INDESIT company

BA35FNF

F031700

RE0231T0 (... - 61112...) Exploded views

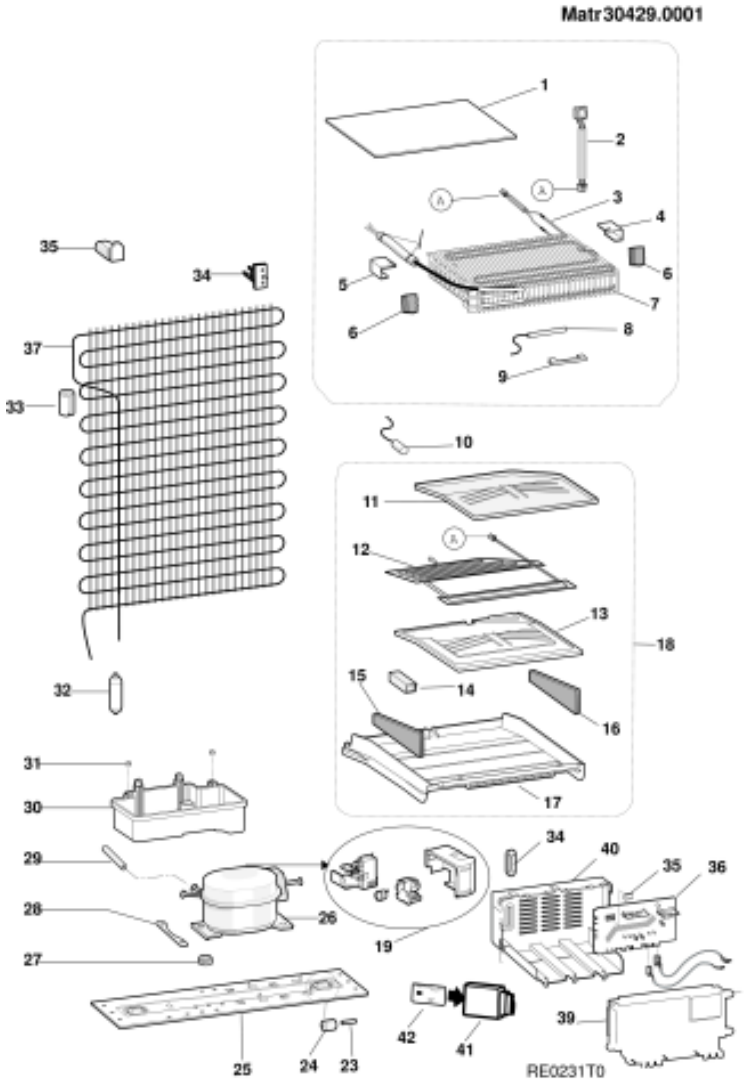
0999364: new fin evaporator and rezistance

Since 01/04/05 new fin evaporator end new rezistance will be used on EU combi models. New parts as an assembly can be used on the appliances which are produced before the modification.

New parts;
115198- fin evaporator
115199- new evaporator rezistance

To fit new evaporator follow below procedure;
· First of all fin evaporator should be positioned at right and back of the freezer roof and than right bracket should be screwed like previous manner (the same track of the hole for right bracket exists on the cabinet). Use the evaporator as a template to screw and position the left bracket symmetricaly.

0999376: ICE FORMATION AT THE BACK OF THE EVAPORATOR

Below modifications have been performed to prevent ice formation at the back of the evaporator on L70 combies. These new parts can be supplied as an assembly C00141277
1- Spugnetta evaporatore left and right have been modified since 12/08/2005. Spare part codes remain the same (C00094468-C00094467). These parts must be replaced together in case of necessity of the replacement.

2- Power of the rezistance for divisorio camere has been increased from 40W to 50W since 03/10/2005. Spare part code remains the same (C00095774).

3- Power of the rezistance for evaporator has been increased from 140W to 150W since 26/09/2005. Spare part code remains the same (C00115199).

4- Drain hose end piece C00141278 has been used for draining the water to the evaporating tray since 26/09/2005.

RE0250T0 (... - 61112...) Exploded views

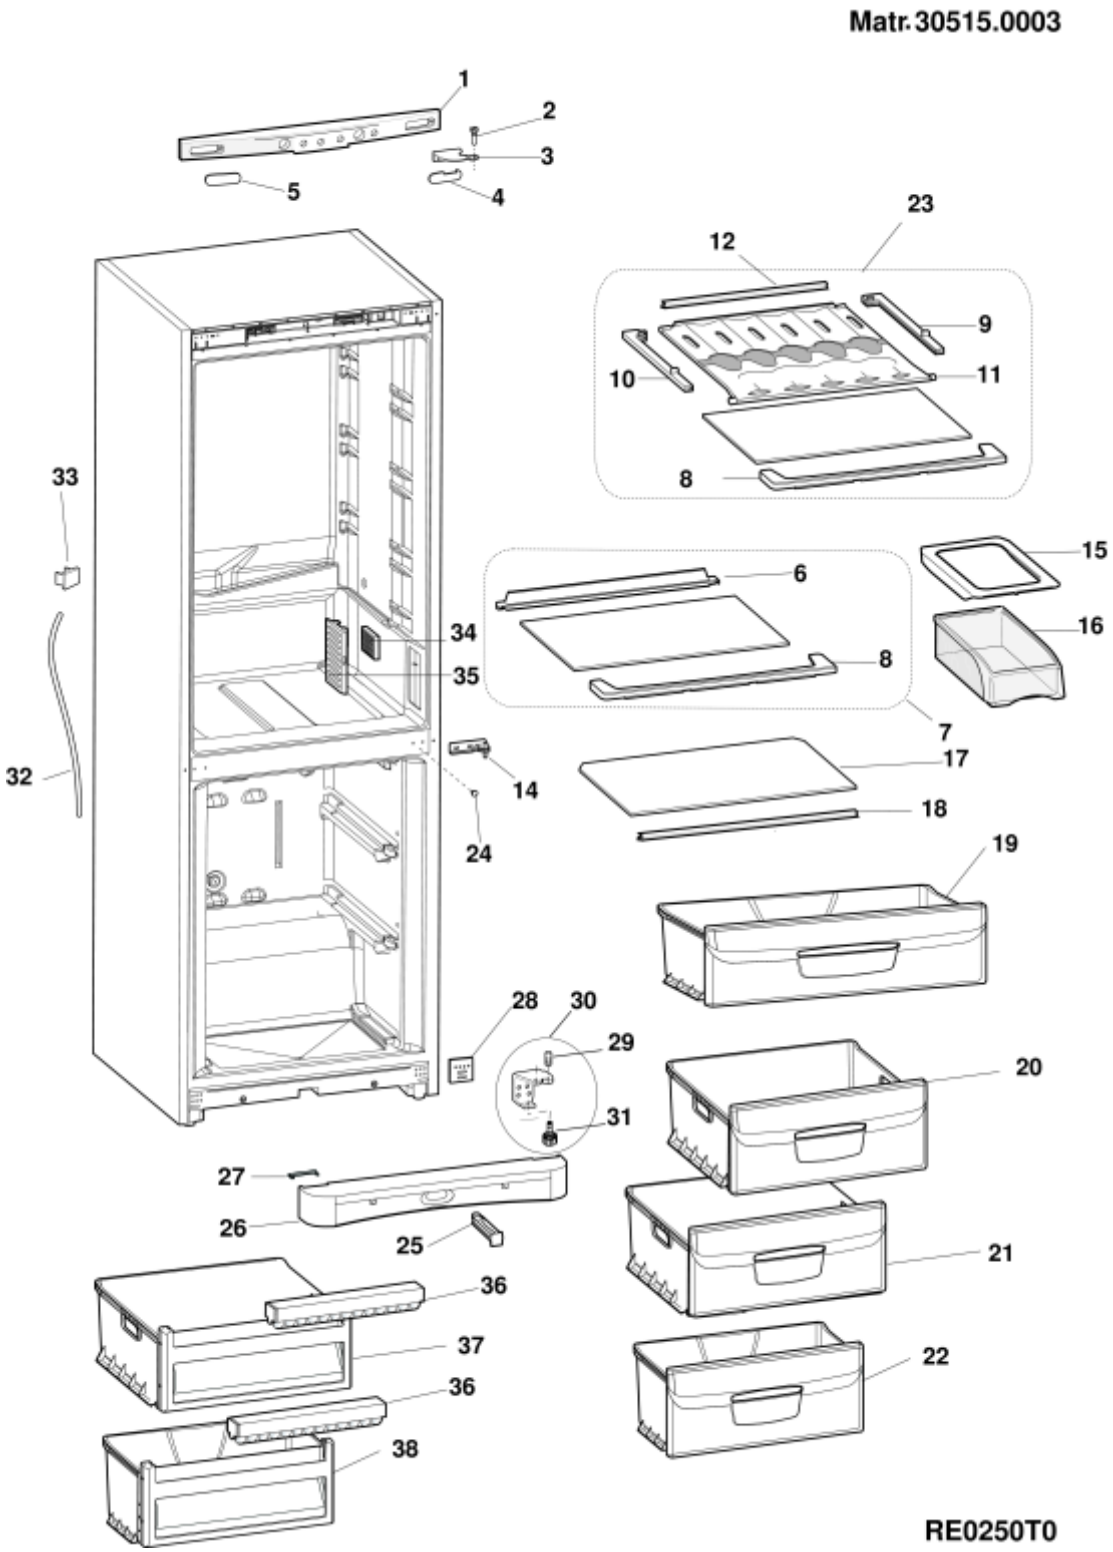
n3010b02: PLAYZONE ELIMINATION

Playzone shelf has been eliminated in Manisa and Lodz production and replaced with a normal shelf already present in interested models.
These spare parts will not managed at the end of stock.

RE0252T0 (... - 61112...) Exploded views

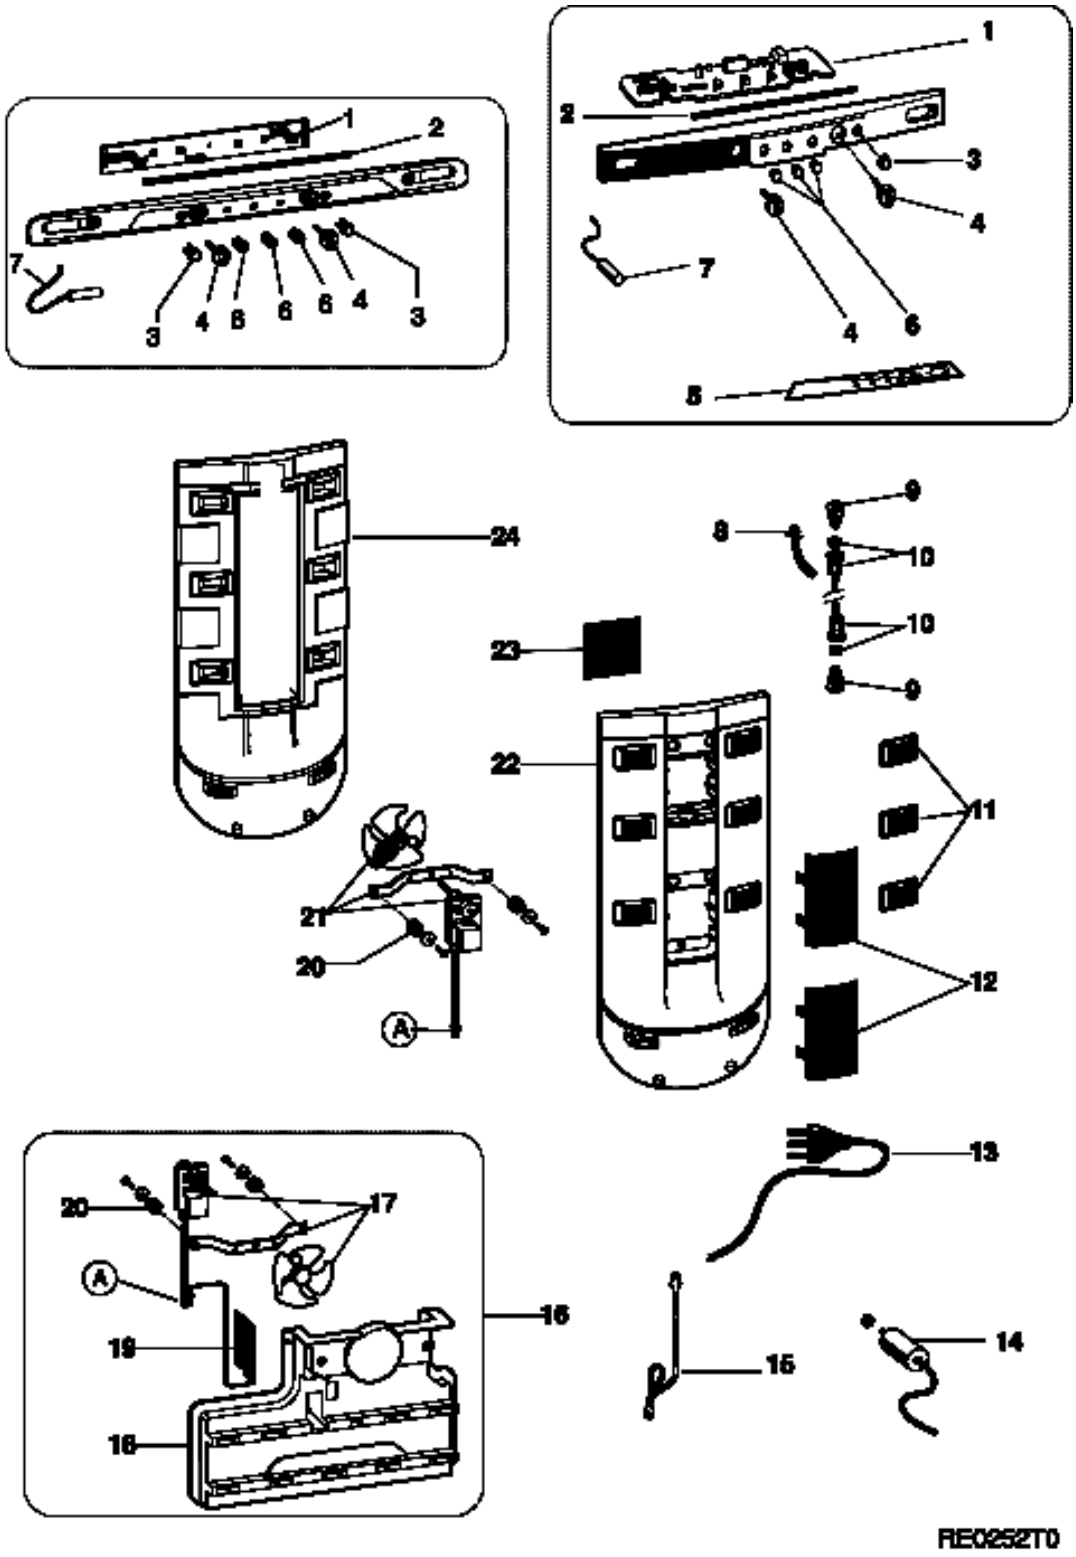
5- Fan motor plastic assembly has been modified. The hole for propeller has been modified to prevent friction between propeller and fan motor plastic since 03/10/05.
Spare part code remains the same (C00116498).

0999379: TWO HOLES HAVE BEEN CANCELLED ON MULTIFLOW FOR COMBIES

Due to low temperature at the lower part of the fridge section on Manisa combies two holes which are placed on multiflow cover have been cancelled for all combies since 13/04/2006.
